CERTIFICATE OF APPROPRIATENESS

Property: 311 W. 13th Street, Tracts 11B and 12B, Block 173, Houston Heights Subdivision. The property includes a historic 1,805 square foot one-story wood frame single-family residence situated on a 4,400 square foot (44' x 100') interior lot that abuts an alley on the west side.

Proposal: Project Type – Construct a rear two-story 3,500 square foot addition with an attached garage to a one-and-a-half story 1,800 square foot contributing residence. Addition will begin at the rear wall and will measure approximately 30' wide, 37' deep, 22'-6" to the eave, and 32'-6" to the ridge. Further alterations proposed for the historic residence include: Raising the foundation from 2' to 2'-8"; replacing existing round porch columns with brick piers topped with wood tapered columns; installing a drop beam above the porch columns, removing the existing eave return condition.

SOUTH ELEVATION – FRONT FACING W. 13th Street

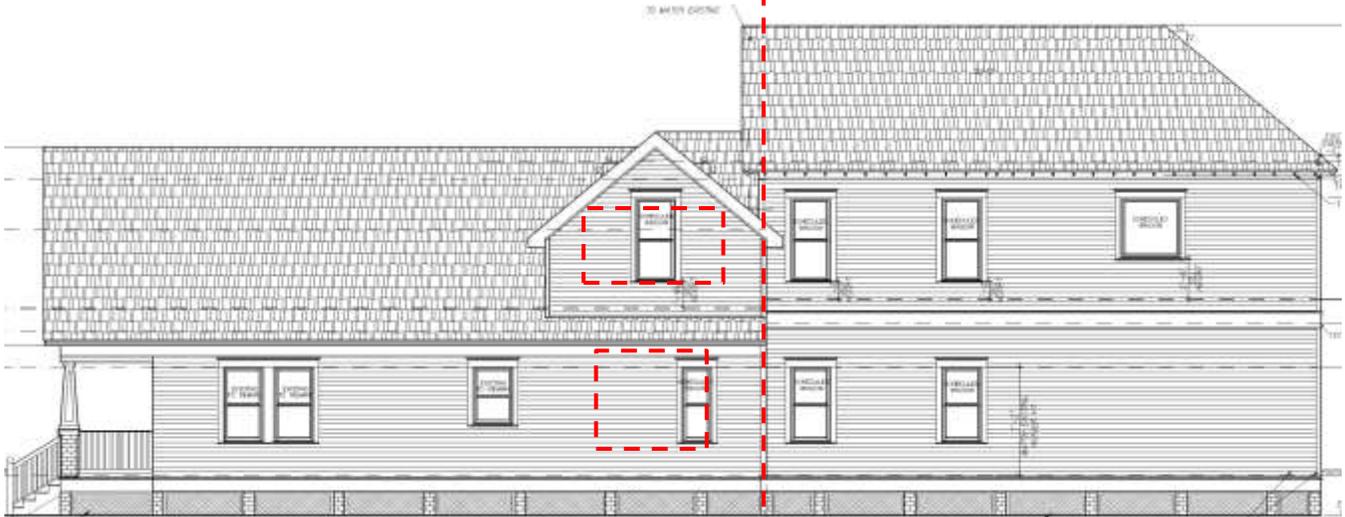
<i>The round porch columns, eave elements and foundation height should be retained to preserve the historic character of the residence. The steeply pitched front gable of the addition increases its visual impact. Modifying the addition roof to a hip would reduce the impact and preserve the historic character of the single story residence.</i> |

<i>The front gable bungalow constructed circa 1915 features elements with Colonial Revival influence (i.e. round columns and eave returns). The removal and replacement with Craftsman influence elements (tapered columns with brick piers) creates a false sense of history and is not compatible with the historic character of the residence.</i> |

<i>The round columns and eave returns are stylistic features of the residence and should be maintained.</i> |

Removal of the round columns, eave returns, and siding materials at the lower portion of the front gable results in the loss of historic materials and compromises the character of the residence. Modifying the addition roof from a gable to hip would preserve the single story character of the property and scale compatibility with the area in which it is located.

- **Modify the addition front gable roof to a hip roof.**
- **Retain the following existing conditions: 2' foundation height; round front porch columns; front gable eave returns.**

- **Modify the addition front gable roof to a hip roof.**
- **Retain the following existing conditions: 2' foundation height; round front porch columns; front gable eave returns.**

ROOF PLAN

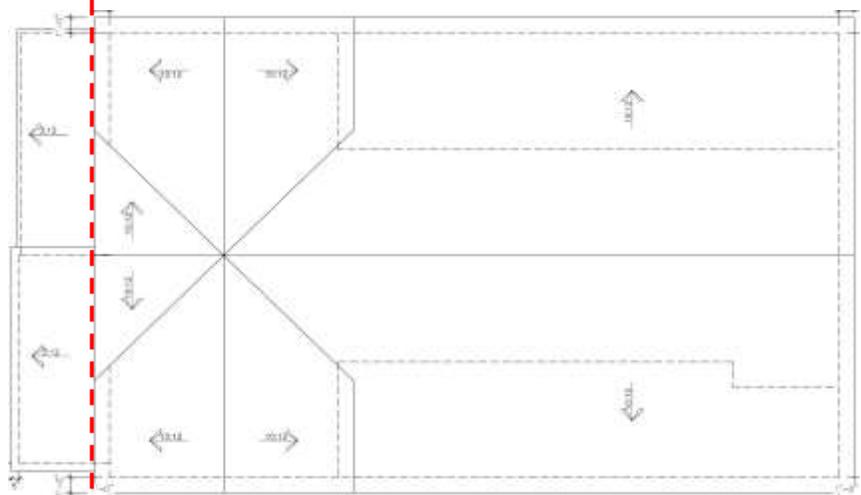
<i>The round columns, eave returns, foundation condition and single-story character are distinguishing characteristics of the residence and should be preserved. Modifying the addition roof from a gable to hip would reduce the impact of the addition, preserving the single story character of the property and its environment.</i> |
